## REPORT TO CITY COUNCIL

Amendment to the Option and Structure Lease Agreement with AT&T Wireless to expand the Lease Area to Accommodate Electrical Equipment

## FIRST AMENDMENT TO OPTION AND STRUCTURE LEASE AGREEMENT

**EXHIBIT 1-A**

SHEET TITLE:  
**ENLARGED SITE PLAN**

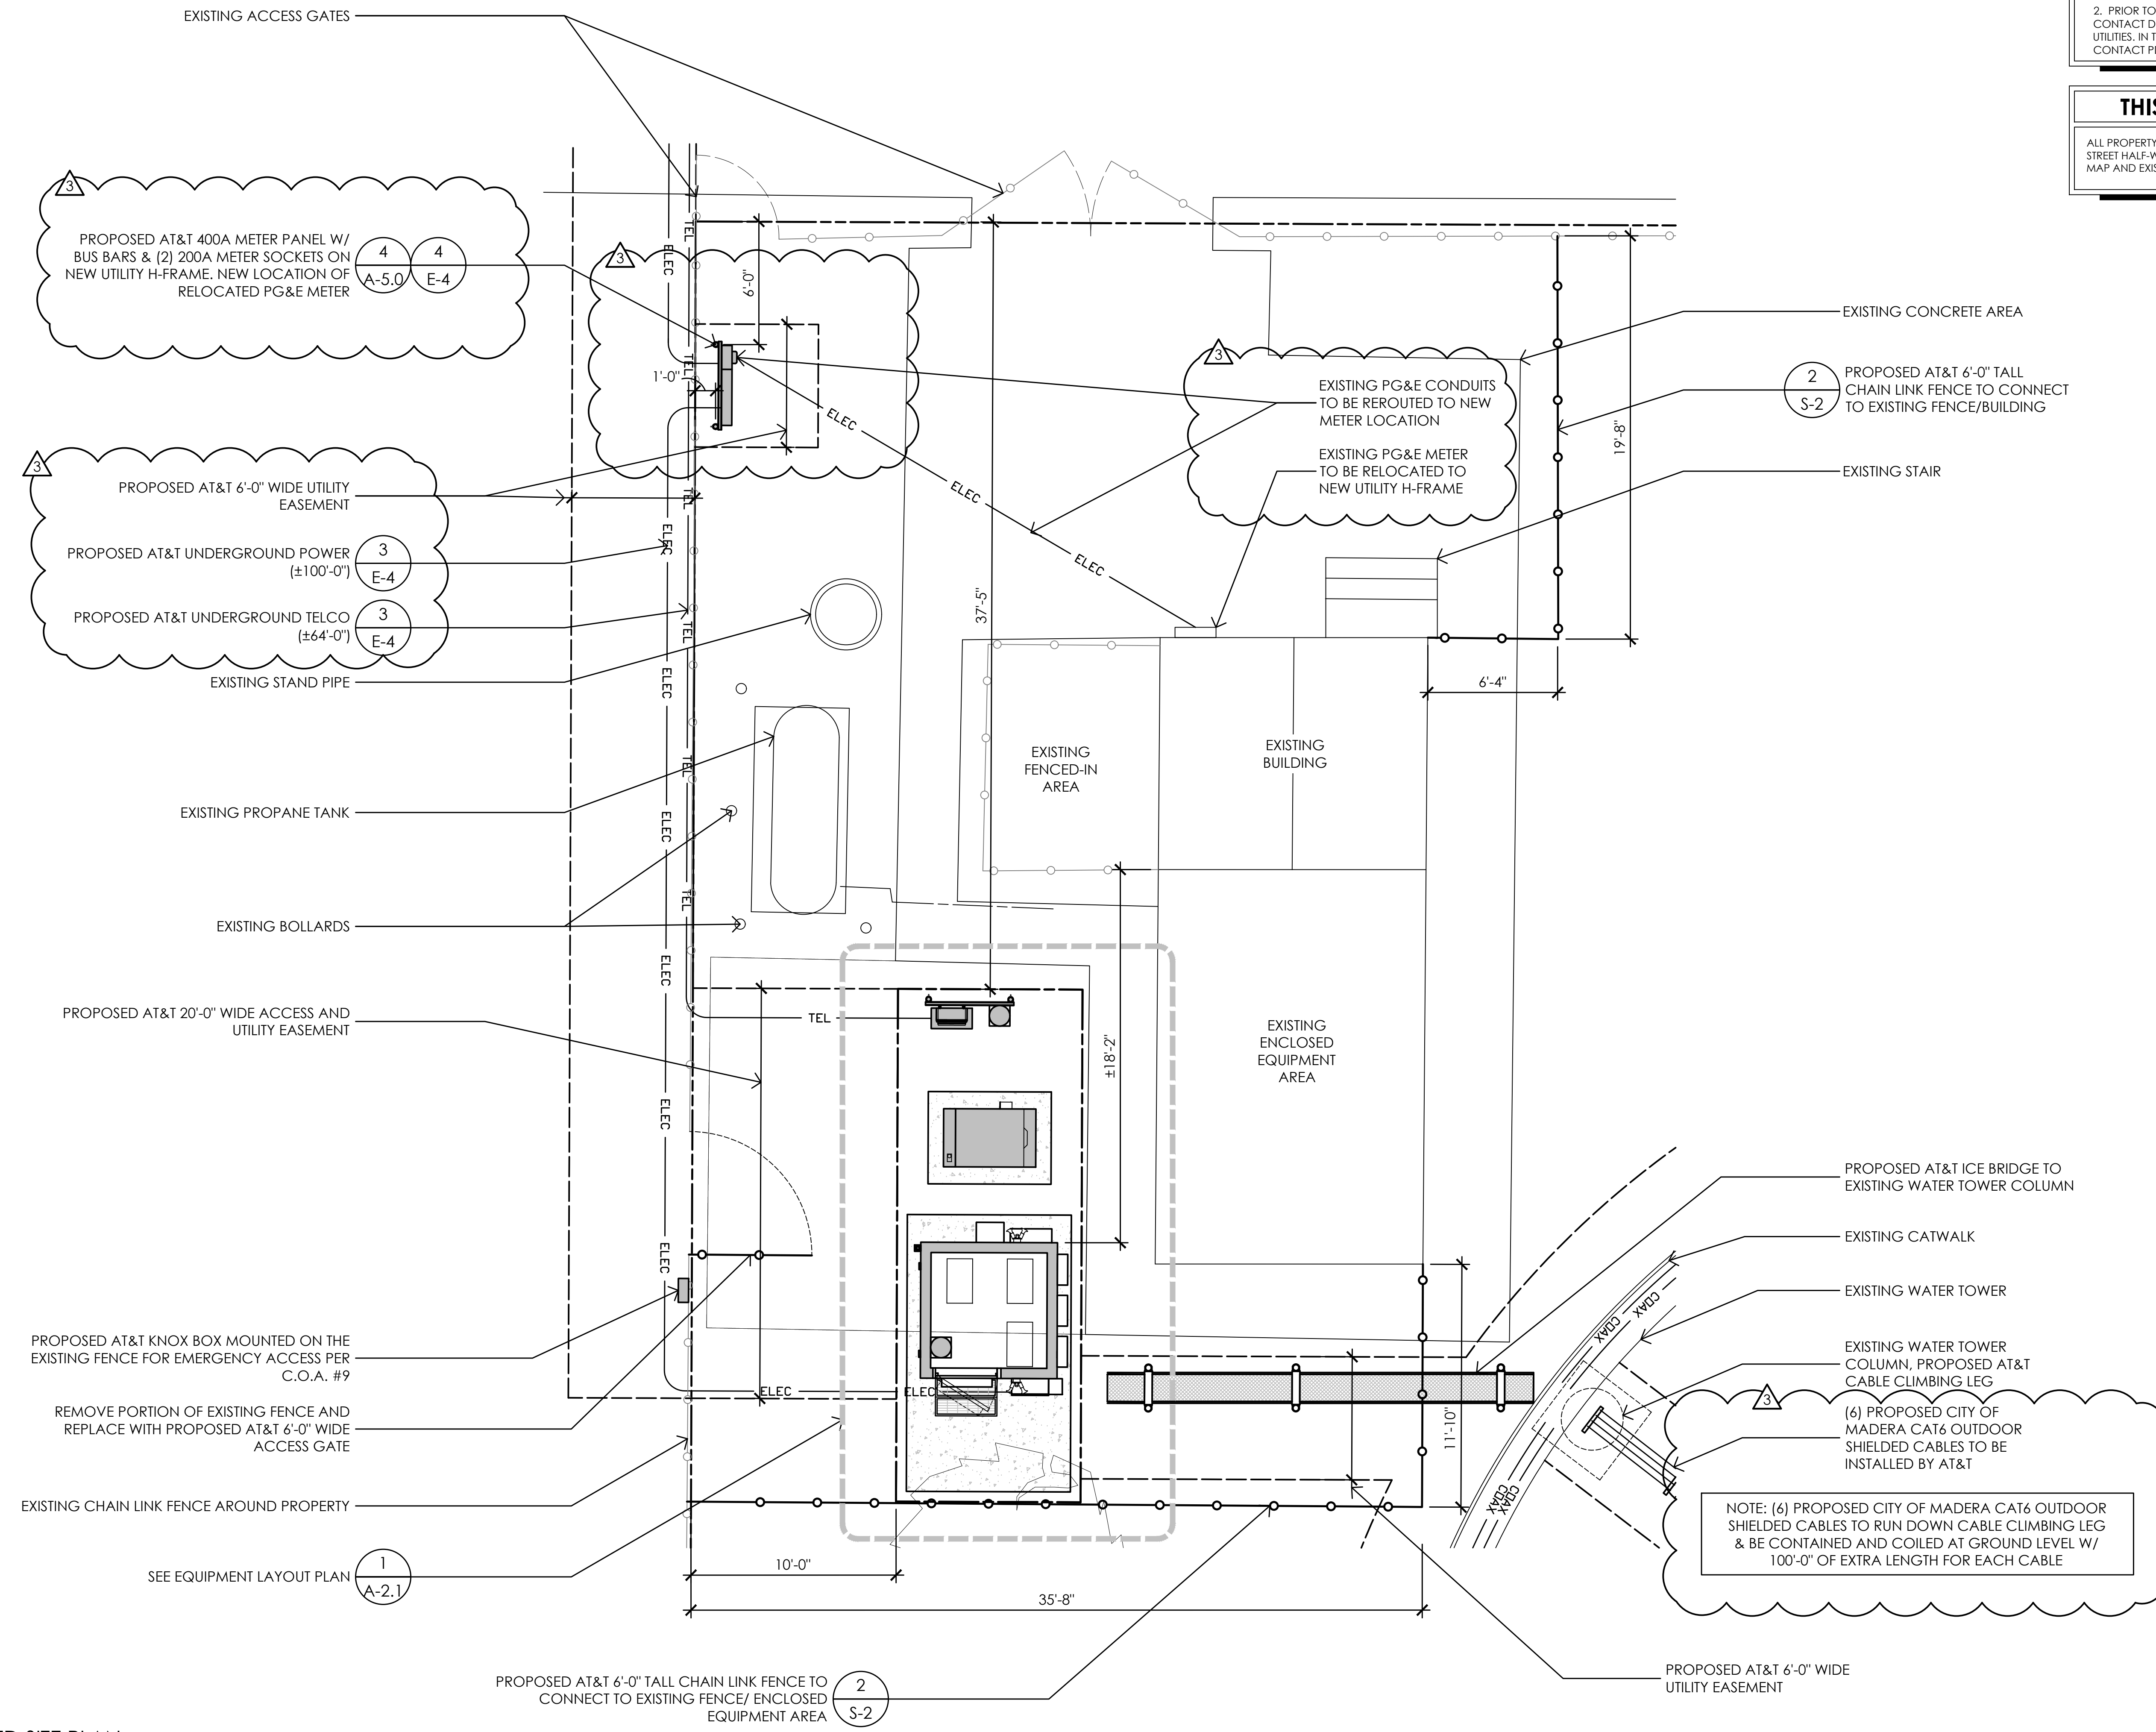
During the construction process, it was determined that the PG&E meter for the project was not able to be placed inside the planned location area due to site constraints. The original plan had the meter being placed inside of the AT&T utility easement location. The meter has now been placed north of this location, closer to Columbia Street proximate to the alley. The resolution would extend the utility easement for AT&T to accommodate the relocation of the PG&E meter (Exhibit 1-A / Page A-1.2).

- Exhibit 1.** Exhibit 1 to the Agreement is replaced with Exhibit 1-A attached hereto to memorialize the redesign and expansion of Tenant’s utility route and h-frame placement.
- Notices.** Section 17 of the Agreement is modified to reflect the following addresses for the parties:
